RE: **Mercado el Milagro**
10000 Central SW
Conceptual Grading Plan Stamp Date: 9/6/19
Drainage Report Stamp Date: 9/6/19
Hydrology File: L09D042

Based on the submittal received on 9/9/19 the above-referenced submittal is approved for Site Plan for Building Permit.

RE: L09D042–Mercado el Milagro

Please see attached for a revised grading & drainage plan. Your comments for Site Plan for Building Permit from August 7, 2020 (attached) are addressed below.

PERIMETER WALLS

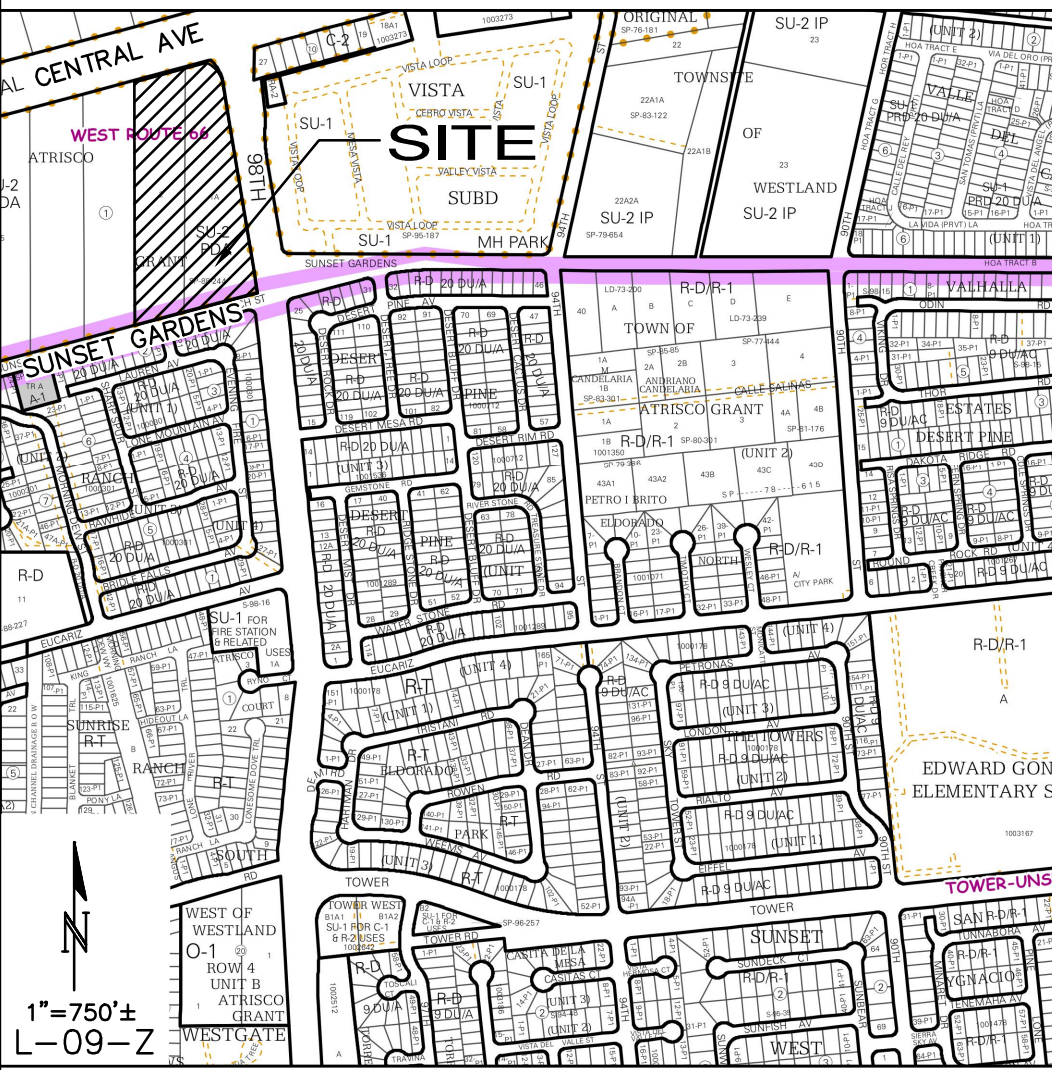
1. Additional detail is required on the retaining wall:
 - a. A structural design for wall with showing how a reversed footer will be built on the property line.

- b. Grades in the adjacent lot, top of wall, and bottom of wall elevations, showing tie-in at property line along the length of the wall.
 - c. A detail of the spillover structure showing how flows will be accepted into this site.

2. The wall design will be addressed with the detailed building permit sets for each phase.
 - a. Structural wall design will be provided with the building permit plans for each phase. A typical perimeter wall section is shown on the conceptual grading plan stating that the wall or footing cannot extend onto adjacent properties without permission.

- b. Top/bottom of wall elevations shall be provided with building permit plans.
 - c. Blocking offsite flows to pond and overflow to Sunset Gardens Rd. was not approved—offsite flows have to be accepted. The conceptual grading plan showing the ultimate buildout has been revised to include a pond to accept the offsite flows from the west and a weir overflow structure by the south entrance to direct the flows to Sunset Gardens Rd. As each phase develops, the offsite flow shall be addressed.
